Template for comments and secretariat observations

Date: 2017-01-10	Document: ACDC 02-04e GWG Comments on ACDC 02-03e	Project: ACDC
------------------	----------------------------------------------------------	---------------

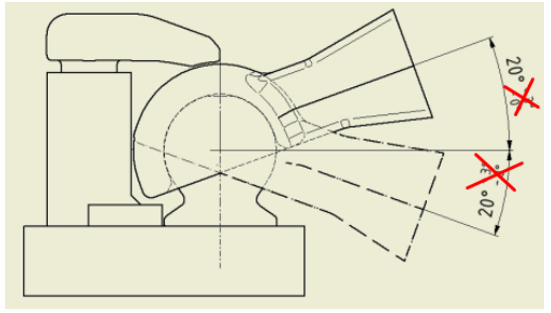
MB/ NC ¹	Line number	Clause/ Subclause	Paragraph/ Figure/ Table/	Type of comment ²	Comments	Proposed change	Observations of the secretariat
G WG		Annex 5	Figure 3	te	<p>The additional tolerance is not necessary, because the heading requires a minimum of the articulation generally</p> <p>Paragraph: 1.1.3. The coupling balls 80 shall have <u>at least</u> the following angles of articulation, which do not have to be reached simultaneously:</p>		
G WG		Annex 5	3.1.4	te	<p>Coupling and uncoupling process should be always in a direct straight position between coupling ring and coupling device.</p> <p>Any inclined position should be improved.</p> <p>Strike paragraph 3.1.4 complete</p>	<p>Coupling and uncoupling of the coupling ring shall also be possible when the longitudinal axis of the coupling ring in relation to the centre line of the jaw:</p> <p>a) is rotated horizontally 50° to the right or left;</p> <p>b) is rotated vertically 3° up or down;</p> <p>c) is rotated axially 3° to the right or left</p>

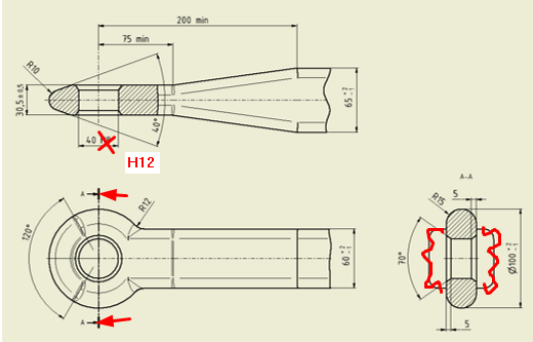
MB/ NC ¹	Line number	Clause/ Subclause	Paragraph/ Figure/ Table/	Type of comment ²	Comments	Proposed change	Observations of the secretariat
G WG		Annex 5	Figure 5	te	The new drawing shows the relevant and necessary dimensions of the structural components in regard of their strength and their interchangeability. Further dimensions and requirements are fixed in other paragraphs and documents and would only be repeated here.	<p>preferred version</p>	
G WG		Annex 5	Figure 6	te	Figure 6 can be removed, information combined in Figure 5

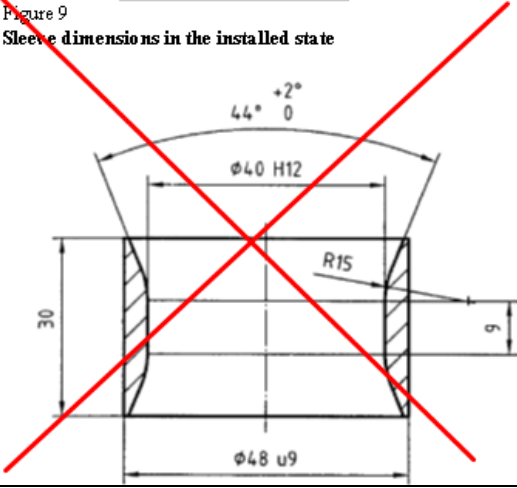
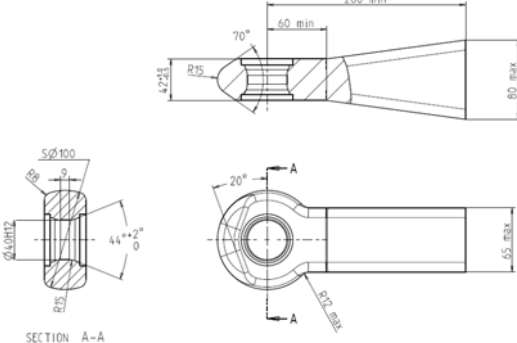
MB/ NC ¹	Line number	Clause/ Subclause	Paragraph/ Figure/ Table/	Type of comment ²	Comments	Proposed change	Observations of the secretariat
G WG		Annex 5	Figure 7	te	The new drawing shows the relevant and necessary dimensions of the structural components in regard of their strength and their interchangeability. Further dimensions and requirements are fixed in other paragraphs and documents and would only be repeated here.	<p>The drawing shows a mechanical part with the following dimensions and features:</p> <ul style="list-style-type: none"> Overall height: 105 min Width of the central section: $30^{+1.5}_0$ Inner diameter: $\varnothing 33^{+0.3}_0$ Top view dimensions: 60⁺⁵/₋₁₅ and 51⁺⁷/₀ Overall width: 150⁺²⁰/₀ Corner radius: R50⁺¹⁰/₀ Angle: 30° min

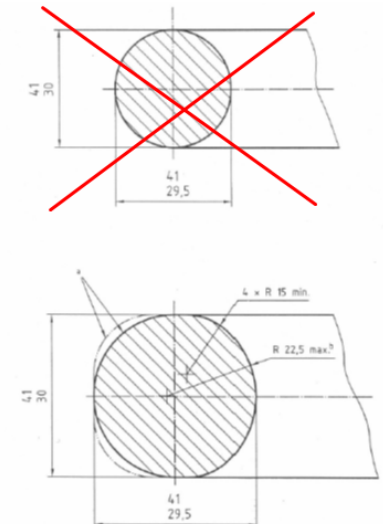
MB/ NC ¹	Line number	Clause/ Subclause	Paragraph/ Figure/ Table/	Type of comment ²	Comments	Proposed change	Observations of the secretariat
		Annex 5	Figure 10	ed	Use min and max instead of arithmetic characters for the tolerance of the values	<p>The drawing shows two views of a toroidal drawbar eye. The top view is a side profile with a diameter of 50 max at the narrow end, a length of 80 min for the narrow section, and a total length of 300 min. The diameter at the wide end is 25 max. The bottom view is a top-down view showing a diameter of 100 max and a length of 200 min.</p>	
		Annex 5	4.3.2	ge	Make two different classes d50-1 and d50-2 for the two different alternative dimensions. D50-1 fit for class g and class h (hook and piton) D50-2 fit only for class g (hook)	<p>Figure 11 Dimensions of toroidal drawbar eye of class d50-1</p> <p>Figure 12 Alternative Dimensions of toroidal drawbar eye of class d50-2</p>

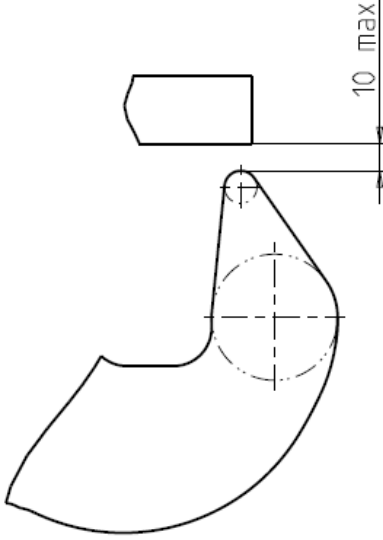
MB/ NC ¹	Line number	Clause/ Subclause	Paragraph/ Figure/ Table/	Type of comment ²	Comments	Proposed change	Observations of the secretariat
		Annex 5	Figure 13	te	The new drawing shows the relevant and necessary dimensions of the structural components in regard of their strength and their interchangeability. Further dimensions and requirements are fixed in other paragraphs and documents and would only be repeated here.	<p>The drawing shows a cross-section of a structural component. It features a curved top edge with a radius of R14₋₃. A vertical dimension of 44₀⁺¹¹ is shown on the left. A horizontal dimension of 12.5₋₃⁺¹ is shown at the top. A circular hole with a diameter of Sϕ47_{-1.6}⁰ is located on the right. A vertical dimension of 16₀⁺³ is shown at the bottom right. A surface finish symbol SR7₀ is indicated on the top surface.</p>

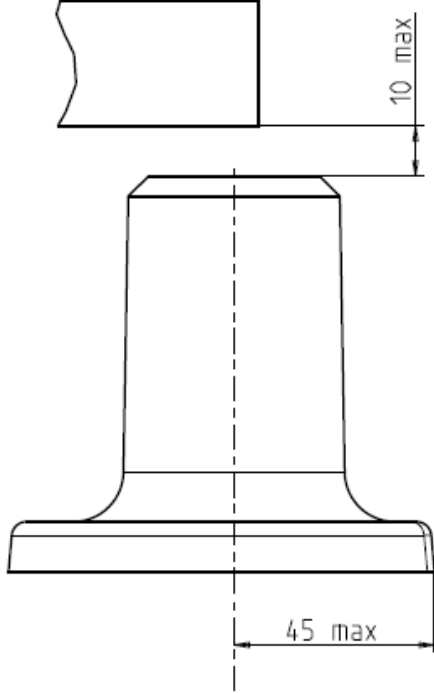
MB/ NC ¹	Line number	Clause/ Subclause	Paragraph/ Figure/ Table/	Type of comment ²	Comments	Proposed change	Observations of the secretariat
		Annex 5	Figure 15	te	The new drawing shows the relevant and necessary dimensions of the structural components in regard of their strength and their interchangeability. Further dimensions and requirements are fixed in other paragraphs and documents and would only be repeated here.
